<b>Notice of Allowability</b>	<b>Application No.</b>	<b>Applicant(s)</b>	
	10/810,142	GUTMARK ET AL.	
	<b>Examiner</b>	<b>Art Unit</b>	
	Ted Kim	3746

### EXAMINER'S AMENDMENT

FIG. 4

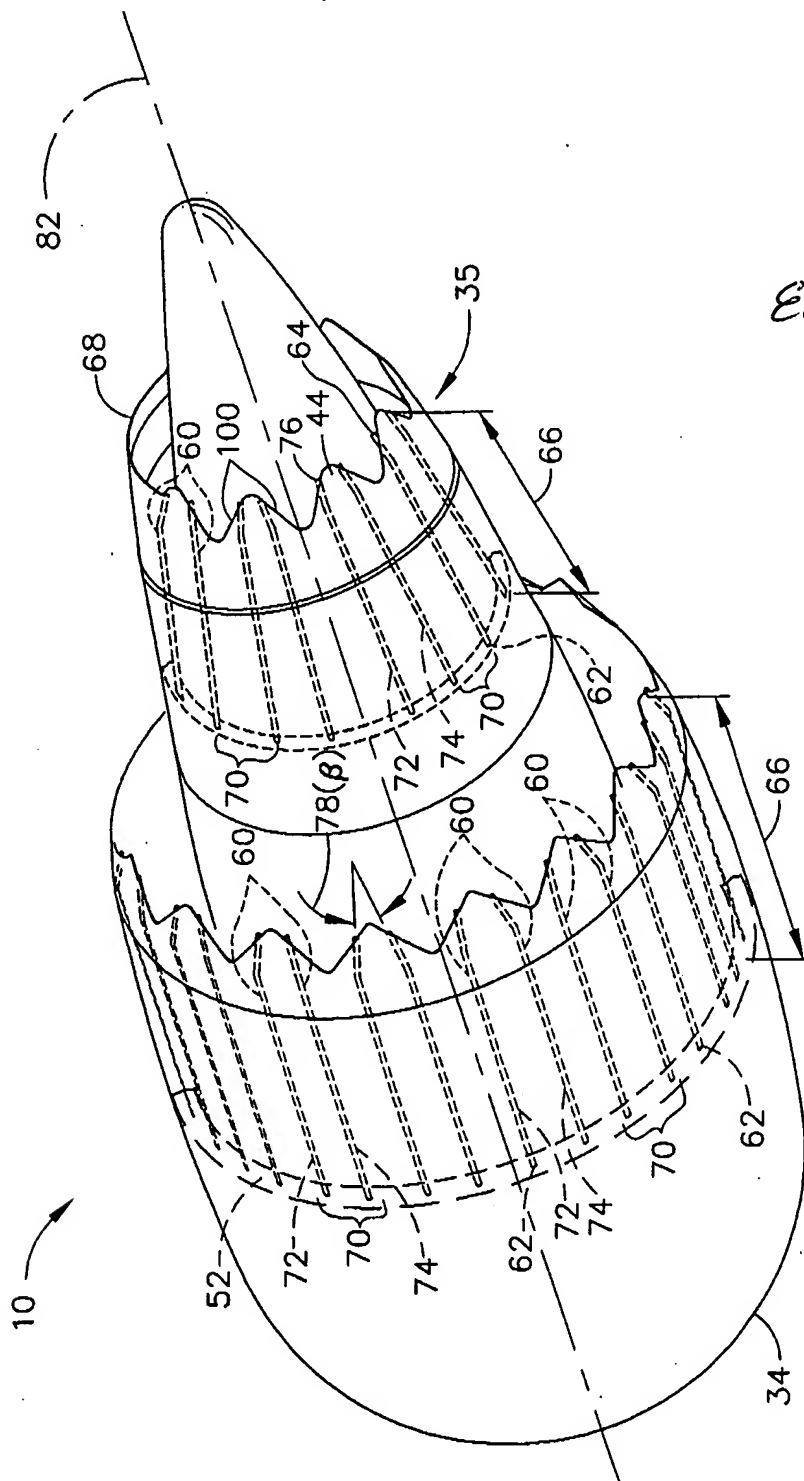
*Entry Approved*

*Figs 4.6*
